## SERVICE TECHNICAL INFORMATION

### ONE POINT REPAIR

REF. NO. : SI-96-013

MODEL : CSD-ES50 / ES60 / ES70 / CA-DW700M / NSX-E7M  
SUBJECT : Remote control does not operate  
SYMPTOM : The height of the positive terminal (+) with some AA batteries is low. When such batteries are used, the battery does not make contact with the positive terminals (+) of the remote control unit and so the unit does not operate.

Remote Control (bottom)

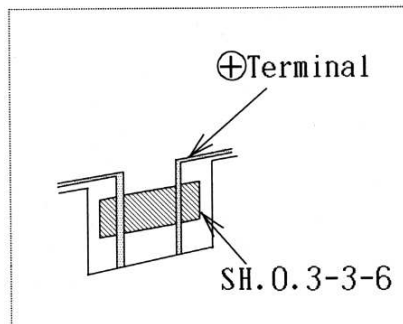
REMEDY : Attach a spacer to the positive terminals (arrow) of the remote control unit (refer to the figure below).

Use tweezer to attach to the back of the positive terminal.

Part No.	Part Name	Ref. No.
SV-T00-024-010	SH, 0.3-3-6	—
